CORAL COAST MARINA DEVELOPMENT

CLARIFICATION TO MATTERS ARISING FROM THE RESPONSE TO SUBMISSIONS, NOVEMBER 2001

OCTOBER 2002

REPORT NO: 2002/144

FIGURE 4

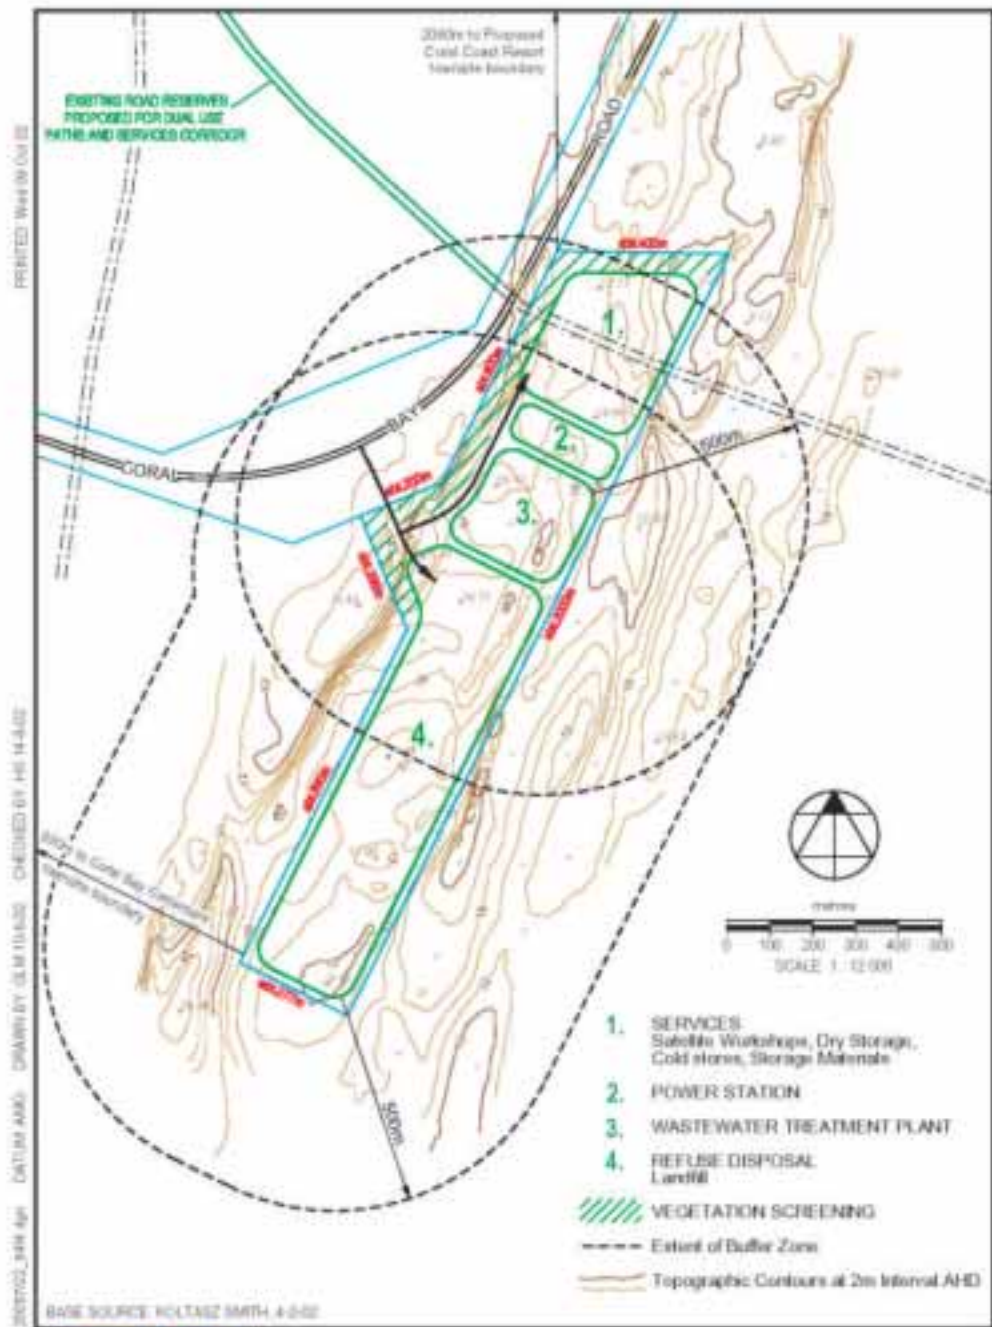
Further detail should be provided on the indicative layout of the Services Area, including:

Please clarify "A visual barrier will be constructed across swale at the northern extent of the services area..."

Figure 4 in Appendix 4 presents a proposed layout for the services area. The services area will be located in an interdunal depression proposed to be located approximately 2.8km south of the CCR (Figure 1 in Appendix 4). The perimeter is approximately 1.5km from the Coral Bay settlement and approximately 2km south east of the runway at the Coral Bay airstrip.

Figure 4 in Appendix 4 presents an indicative services area layout plan. The figure also indicated contours. To in part manage visual amenity and light over-spill issues, services are proposed to be located in the interdunal swale. Visitors and residents travelling in a general southerly direction down the Coral Bay Road will view the services area. The statement refers to CCMD's intention to bridge the relevant area between the two adjacent crests with a view to screening this area and limiting any hazards night time lighting may have on traffic. The bund will be rehabilitated using local genotypes, and access road will be curved so passing traffic does not have direct line of sight.
